HISTORIC AND DESIGN REVIEW COMMISSION

HDRC CASE NO: 2021-026
COMMON NAME: Unaddressed lot to the immediate south of 334 Burleson, on N Mesquite
ADDRESS: 334 BURLESON ST
LEGAL DESCRIPTION: NCB 519 BLK 24 LOT E 42 FT OF N 134.09 FT OF 8
ZONING: IDZ-1, H
CITY COUNCIL DIST.: 2
DISTRICT: Dignowity Hill Historic District
APPLICANT: cesar sosa/5 ELEMENTS INTERNATIONAL LLC
OWNER: Ruben Lara/5 ELEMENTS INTERNATIONAL LLC
TYPE OF WORK: Construction of two, 2-story residential structures
APPLICATION RECEIVED: February 04, 2021
60-DAY REVIEW: Not applicable due to City Council Emergency Orders
CASE MANAGER: Edward Hall

Historic and Design Review Commission
Design Review Committee Report

PROJECT NO. S-363
CONSTRUCTION DOCUMENTS
10 SEPTEMBER 2020

1 ENLARGED SITE PLAN
SCALE: 1/8" = 1'-0"

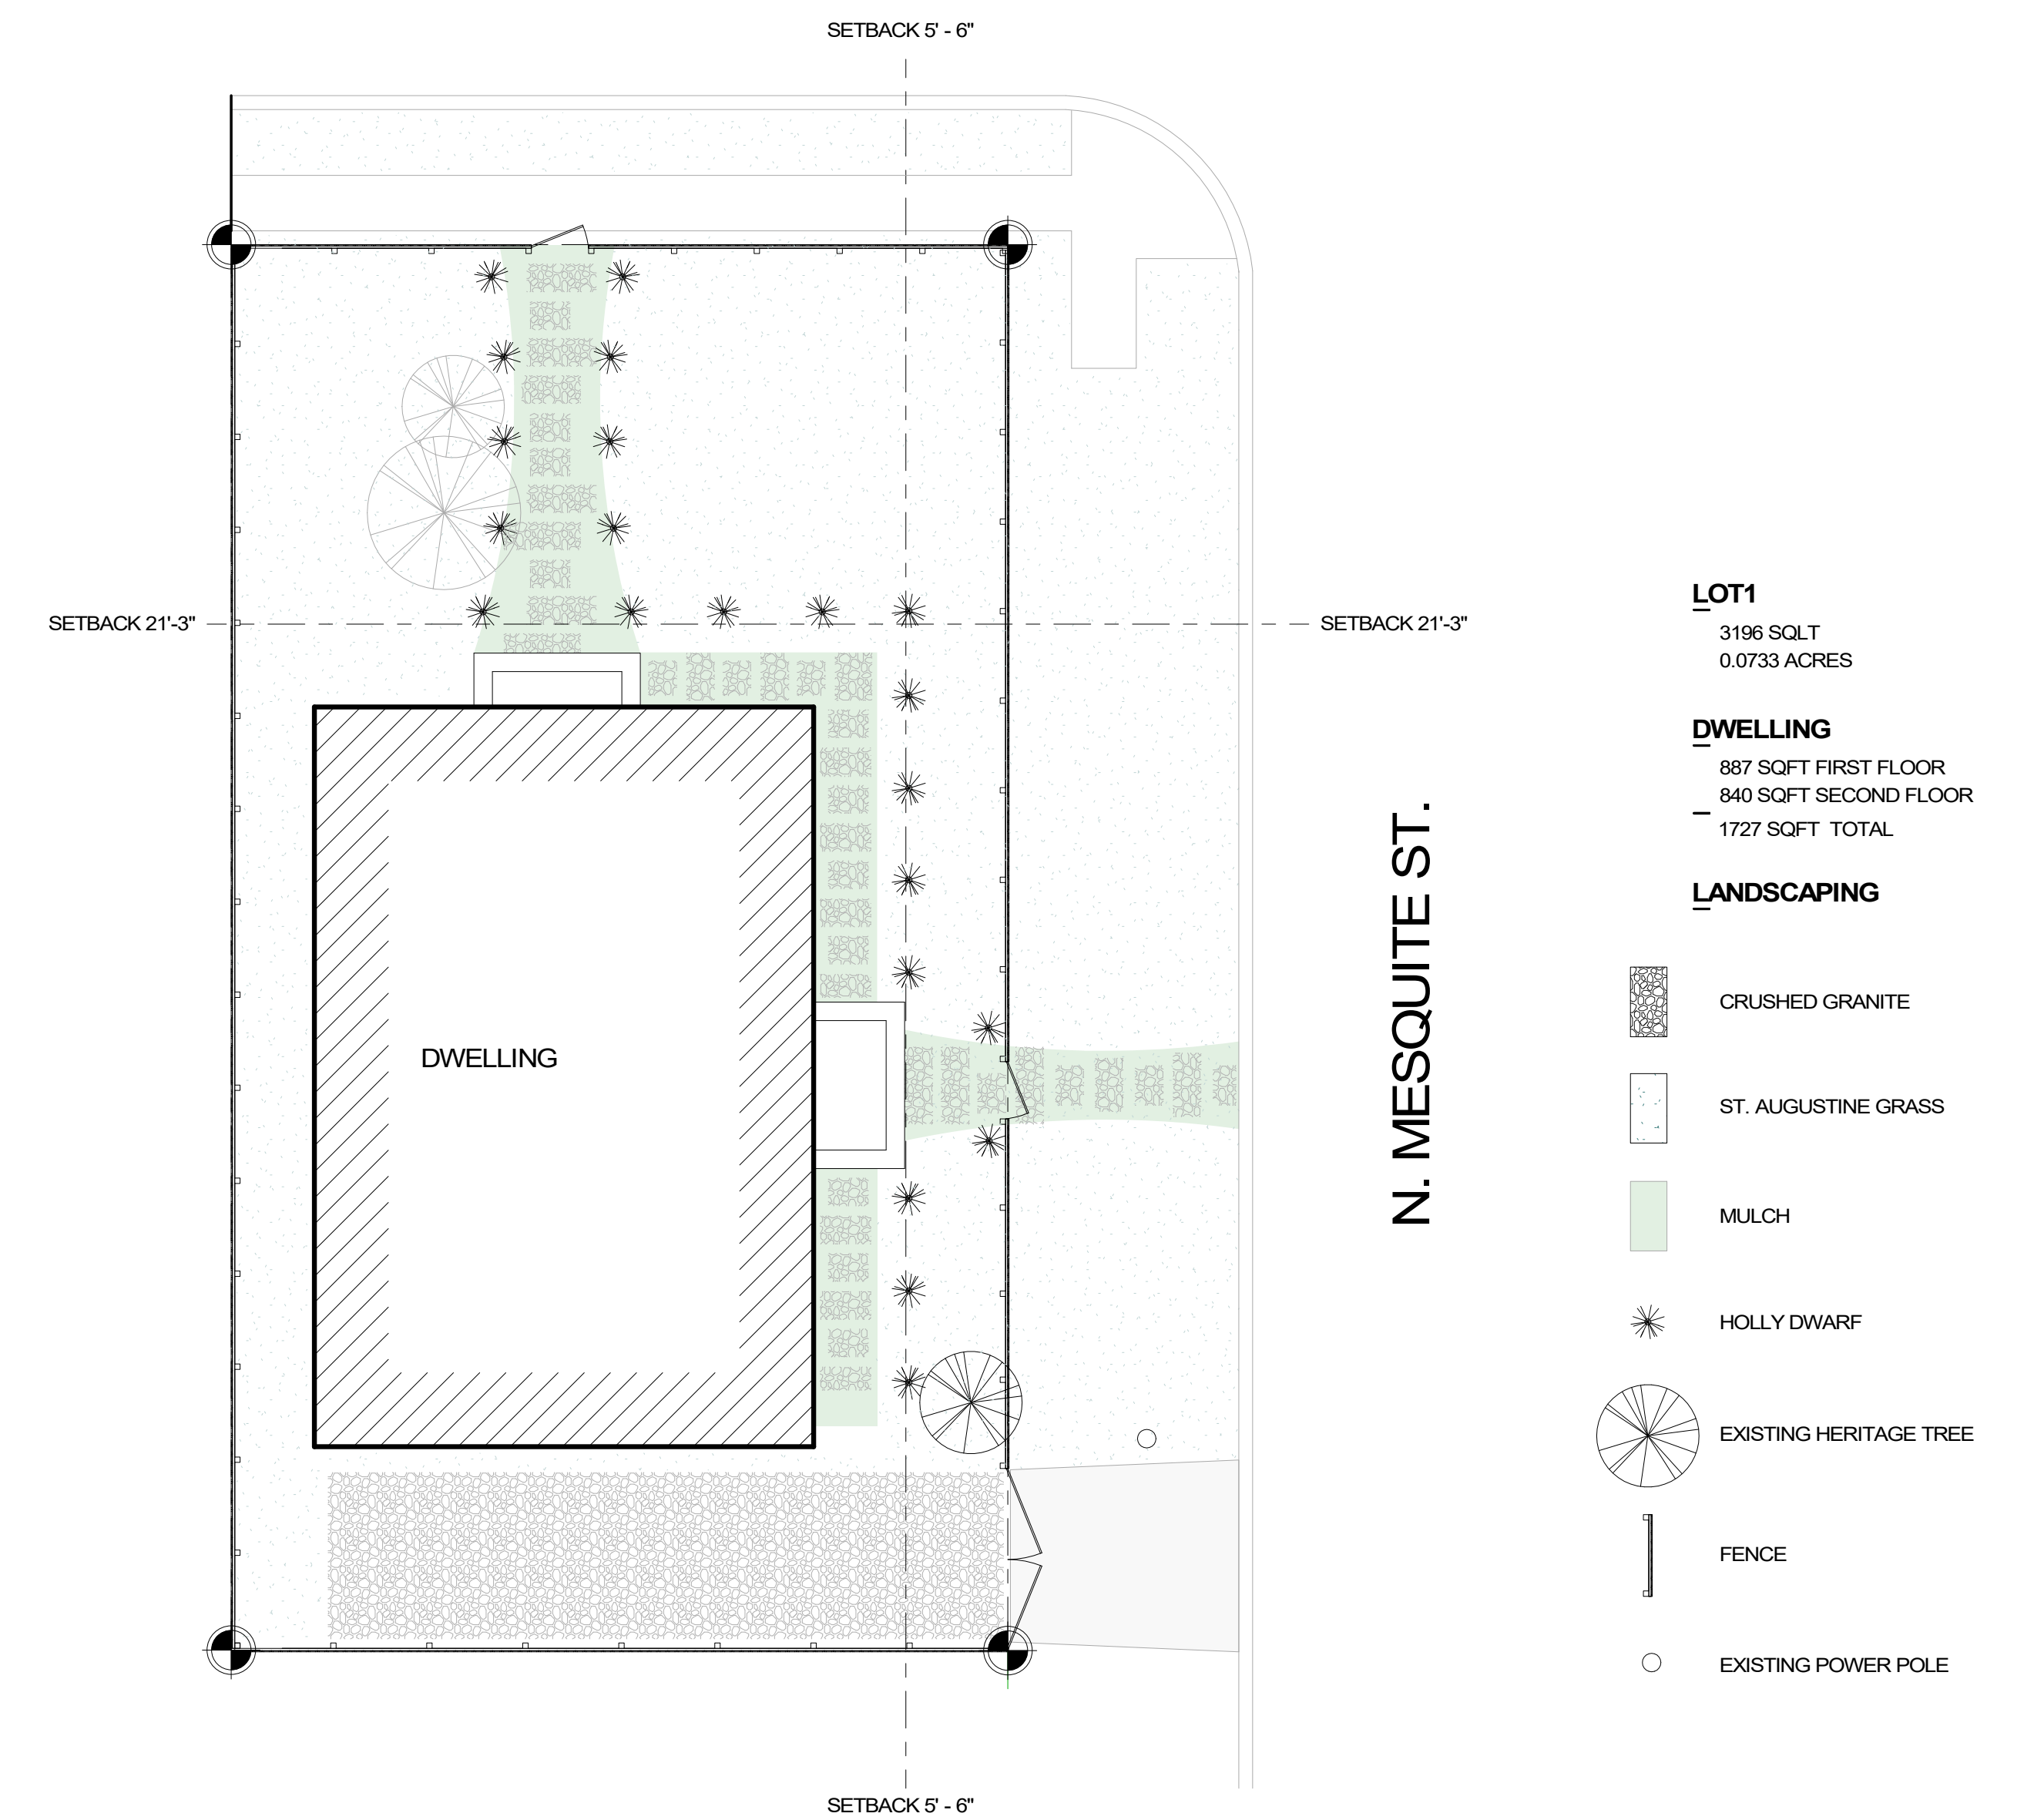
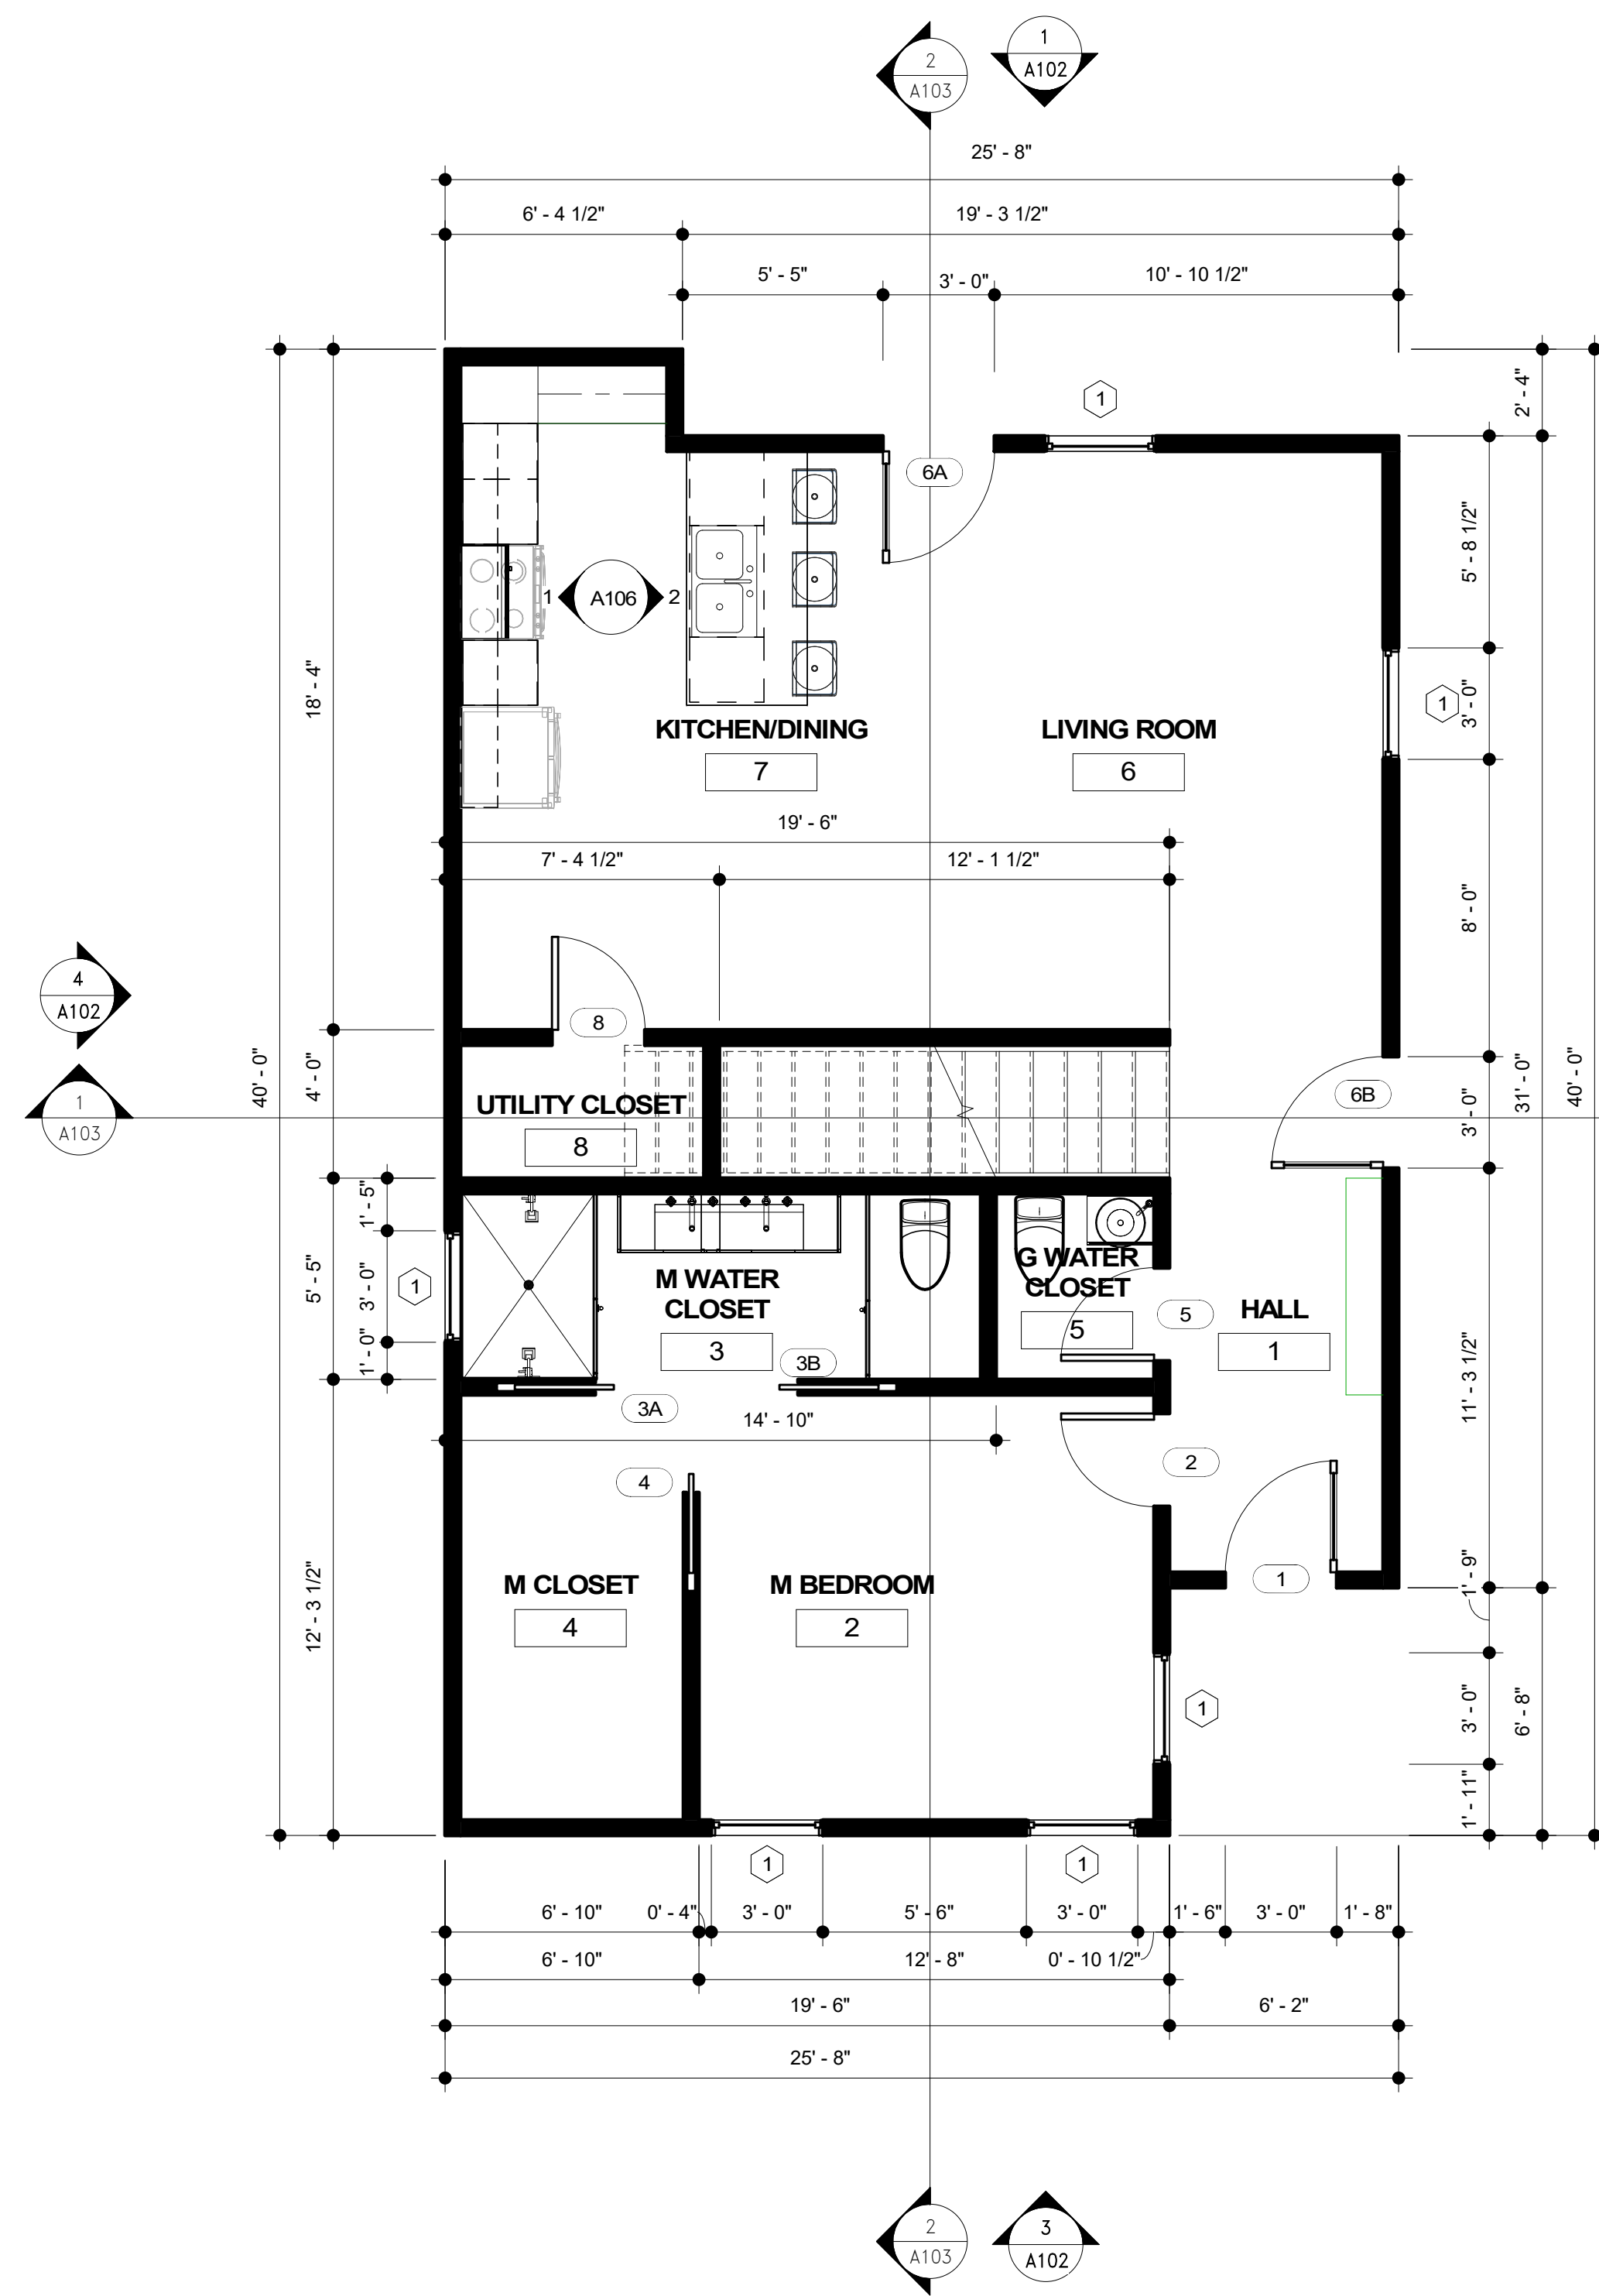
- 1a. **SETBACKS** – The applicant has proposed a setback of twenty (20) feet, which is less than that of the two adjacent one story structures found on this block of Burleson. While the proposed setback is consistent with those of structures found on this block, staff does not find the proposed setback to be appropriate as it will result in a two story structure featuring a setback that is significantly less than the adjacent, one story structure's setback.

- 1g. **LOT COVERAGE** – Per the submitted site plan, the proposed lot coverage is consistent with the Guidelines.
- 1h. **MATERIALS** – The applicant has proposed materials that include wood siding and a corrugated metal roof. Staff finds that the applicant should submit additional information (profiles) of the proposed wood siding. Staff finds that if a metal roof is used, a standing seam metal roof should be installed that features panels that are 18 to 21 inches wide, seams that are 1 to 2 inches in height, a crimped ridge seam or a low profile ridge cap and a standard galvalume finish. All roofing panels should be smooth.

- 1k. **DRIVEWAY** – The applicant has proposed a driveway to the south of the proposed new construction. Corner structures throughout the district feature many driveway locations, including to the interior of the site on the primary street and at the rear of the site on the secondary street. Staff finds the proposed driveway location to be appropriate; however, the driveway should not exceed ten (10) feet in width.

- 1l. **FENCING** – The applicant has proposed fencing parallel to the right of way on both Burleson and N Mesquite. The applicant has proposed a driveway gate to cross the driveway at the right of way. Staff finds that the proposed driveway gate should be located behind the front façade of the new construction.

- 1m. WALKWAYS – The applicant has proposed two paver walkways leading to the right of way on both Burleson and N Mesquite. The proposed profile of these walkways (staggered pavers) is inconsistent with the Guidelines. Staff finds that walkways that feature a continuous concrete profile should be installed, as found historically within the district.
- 1n. LANDSCAPING – The applicant has not provided information regarding landscaping at this time. Staff finds that a detailed landscaping plan should be developed that is consistent with the Guidelines for Site Elements.
- 1o. MECHANICAL EQUIPMENT – The applicant has not noted the location of mechanical equipment. Staff finds that all mechanical equipment should be screened from view from the public right of way.

- i. That the applicant increase the proposed setbacks to be greater than those found historically on both Burleson and N Mesquite, as noted in finding 1a.

- viii. That the proposed driveway not exceed ten (10) feet, that continuous concrete sidewalks be installed, and that a detailed landscaping plan is submitted noting landscaping materials and the location of screened mechanical equipment.
